Technical Service Bulletin

MODEL(S) AFFECTED: **S16 (Machines equipped with non-telemetry capable boards only - Machines equipped with telemetry/telemetry capable boards do not require this update)**

SUBJECT: Machine losing UI (User Interface) board function, preventing sweeping, vacuum fan, and all other functions other than Propel from operating. All membrane assembly LED lights will be nonfunctional.

PURPOSE: Update firmware to revision 1.1.6.66 or higher to prevent losing UI board function due to firmware corruption.

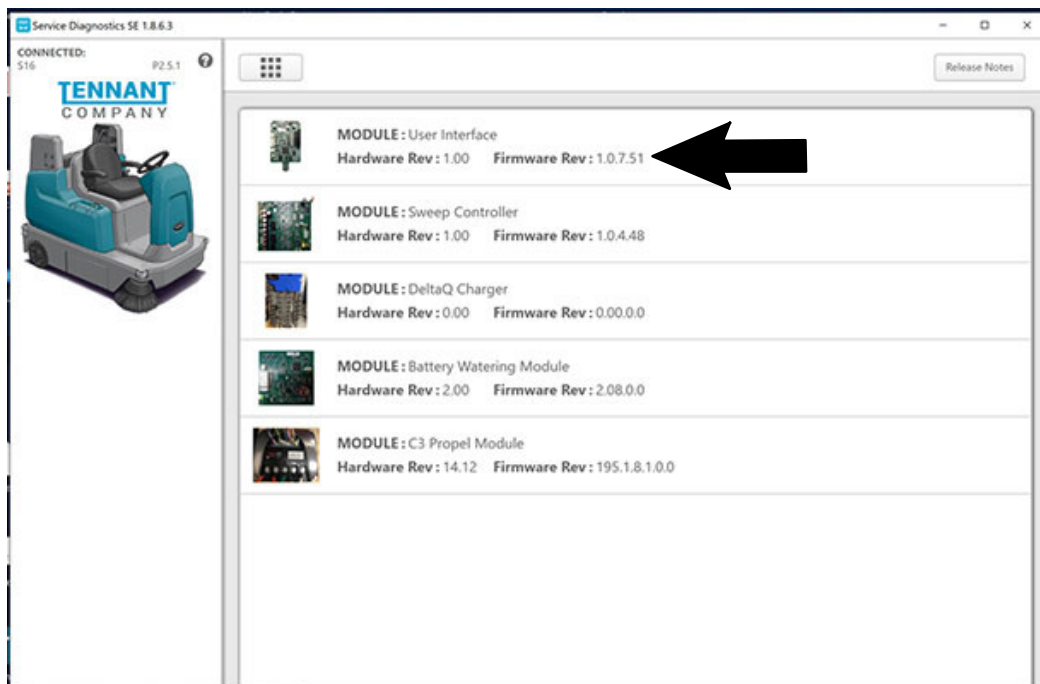
NOTES: Non-telemetry machines require firmware version 1.1.6.66 or later. Refer to flow chart on following page for troubleshooting/updating instructions.
Before performing an update, confirm service device has latest version of Service Diagnostics SE, confirm service device is connected to a network, and Service Diagnostics SE has latest S16 firmware version 1.1.6.66 or later available. Contact T.A.C. for assistance updating resource files if firmware version 1.1.6.66 is not available.

If machine is functioning as intended: Update firmware per instructions in S16 Service Manual.

If machine has lost UI function: Remove UI board/membrane assembly from machine and return to Tennant Engineering for rework per instructions on flow chart on following page and form included with new UI board/membrane assembly.

1. Determine machine Firmware Rev (firmware revision) through Service Diagnostics SE - Firmware Rev should be revision 1.1.6.66 or later.

2. Update machine firmware if firmware updates are available. Refer to flow chart on following page for UI board troubleshooting and firmware update information.
